BC BUILDING CODE INTERPRETATION COMMITTEE

File No: 24-0111

INTERPRETATION

Interpretation Date:	November 18, 2025
Building Code Edition:	BC Building Code 2024
Subject:	Accessible clearance for sliding door without power door operator
Keywords:	Accessible sliding door clearance
Building Code Reference(s):	3.8.3.6.(15)

Refer to Figure A-3.8.3.6.(14) to (16) which indicates identical clearances for the push side of a swing door and both sides of a sliding door.

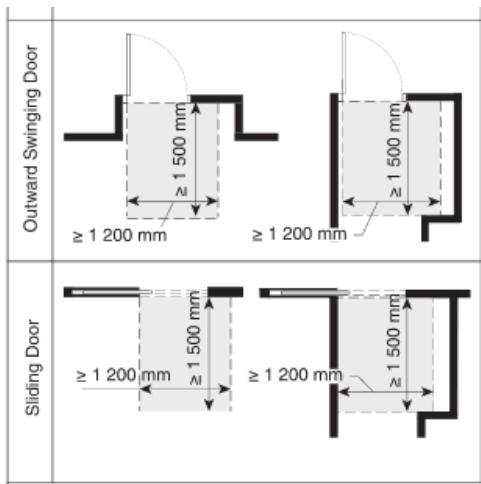
Can the accessible clearance requirement for the sliding door without power door operator be the same as the clearance for the swing door on the push side?

Yes.

Sentence 3.8.3.6.(15) satisfies accessible floor area requirements to reach the handle at the swing door that swings away. The same requirements are sufficient to operate the sliding door on each side.
